Access Compliance Report

Public Rights-of-Way

(Curb Ramps)

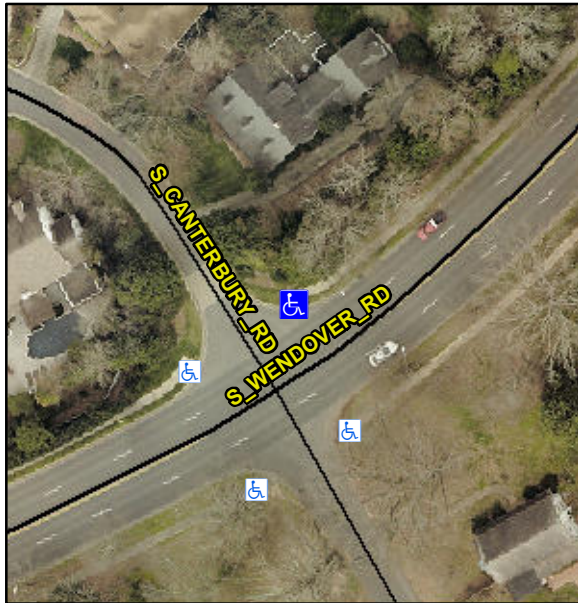
R304.5.1, R304.2.2, R304.5.3

Compliance	Description	Data	Compliance	Description	Data
N/A	Ramp Length (in)	109.0	No	Ramp Slope (%)	14.4
No	Ramp Width (in)	44.0	No	Ramp XSlope (%)	7.4
N/A	Flare Type LT	N/A	N/A	Flare Type RT	N/A
N/A	Flare Slope LT (%)	N/A	N/A	Flare Slope RT (%)	N/A
N/A	Flare Traversable LT?	N/A	N/A	Flare Traversable RT?	N/A
N/A	Landing Length (in)	N/A	N/A	DWS Provided?	N/A
N/A	Landing Width (in)	N/A	N/A	DWS Contrast?	N/A
N/A	Landing Slope (%)	N/A	N/A	DWS Length (in)	N/A
N/A	Landing X Slope (%)	N/A	N/A	DWS Full Width?	N/A
N/A	Landing Curb? (Y/N)	N/A	N/A	DWS Offset (in)	N/A
N/A	Shared Landing?	N/A			
N/A	Gutter Ponding?	N/A	N/A	Gutter Slope (%)	N/A
N/A	Gutter Lip Ht (in)	N/A	N/A	Gutter X Slope (%)	N/A
N/A	Painted X Walk1?	No	N/A	Painted X Walk2?	No
	X Walk 1 Direction	To SW		X Walk 2 Direction	To SE
N/A	X Walk 1 Width (in)	N/A	N/A	X Walk 2 Width (in)	N/A
	X Walk 1 Slope (%)	0.8		X Walk 2 Slope (%)	0.8
	X Walk 1 X Slope (%)	6.0		X Walk 2 X Slope (%)	2.8

Remove & Replace Curb Ramp With Two New Directional Ramps or Equivalent.
